Office Action Summary

10/525,703

RUOTOISTENMAKI, HEIKKI

This detailed action is in regards to United States Patent Application 10/525703 filed on 8/3/2005 and is a first action based on the merits of the application.

**FIG. 1**

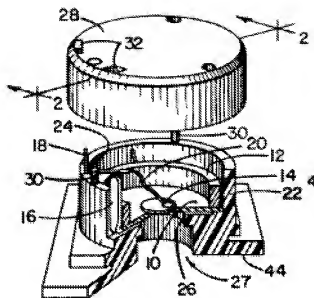
Guscott teaches a transducer device wherein the cover (28) and frame (22) and diaphragm (10) are rotationally symmetrical wherein the frame and cover comprise elements in the shape of bodies of revolution.

Thus, it would have been obvious to a person having ordinary skill in the art at the time of the invention to modify the device taught by Freakes/Reuter to include a rotationally symmetrical frame and cover comprised of bodies of revolution as taught by Guscott in order to provide a circular unit which can be incorporated into fluid pressure monitoring devices connected to circular tubes and because circular frames, covers and diaphragms, covers and frames are all old and well known in the art.

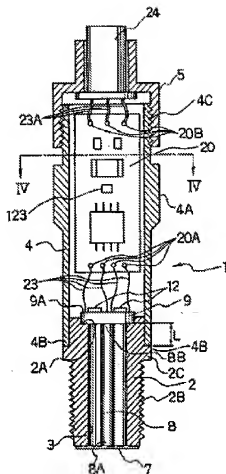
Bagdassarian teaches a SAW device comprised of piezoceramic substrate, see Figure 1 and Column 4, Lines 35-45).

Thus it would have been obvious to a person of ordinary skill in the art to modify the device taught by Freakes to include piezoceramic material as taught by Bagdassarian in the SAW diaphragm in order to provide a material to ensure acoustic wave propagation because when there is a design need or market pressure to solve a problem and there are a number of identified, predictable solutions, a person of ordinary skill has good reason to pursue the known options within his or her technical grasp. If this leads to the anticipated success, it is likely the product is not of innovation but of ordinary skill and common sense.

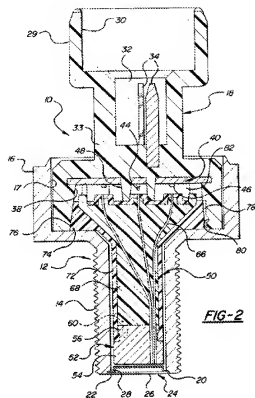
Rogne teaches a pressure sensor with a detection threshold D within a range of about 10^{-7} times the maximum load rating of the device, which is shown as the line F (Failure Line), see Figure 5 and Page 7, Lines 25-30.

Thus it would have been obvious to a person of ordinary skill in the art at the time of the invention to modify the device taught by Freakes/Reuter to have a detectable range of at least 10^{-7} times the maximum load rating of the device as taught by Rogne in order to provide a versatile pressure sensor adapted to be used in various applications requiring different detectable levels, thereby increasing the potential market for the device.
